April 16, 2021

To: All Mitsubishi Service and Parts Managers

Subject: 2022 Outlander Hood Flutter Adjustment Special Customer Satisfaction Campaign

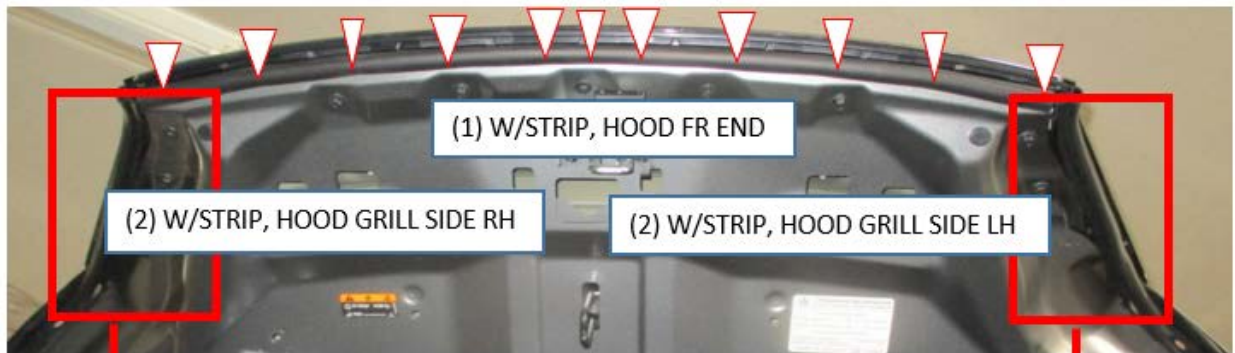
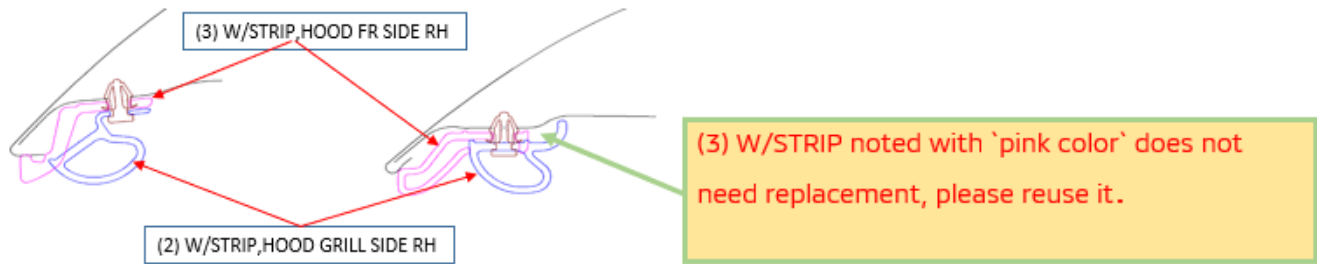
1. Remove the Weather-strip, Hood Front End (1) which is secured by 11 clips and remove the Weather-strip, Hood Grill Sides LH/RH (2), each secured by 7 clips.

Please use the following procedure on all 2022 Outlander vehicles (EXCLUDING ES MODELS) - currently in your inventory and those that will be arriving at your dealership in April - to install countermeasure weather-strips to resolve a hood flutter centered around air intrusion to the engine compartment. This procedure is in addition to TSB-21-42A-001 and will ensure that the wind intrusion is minimized.
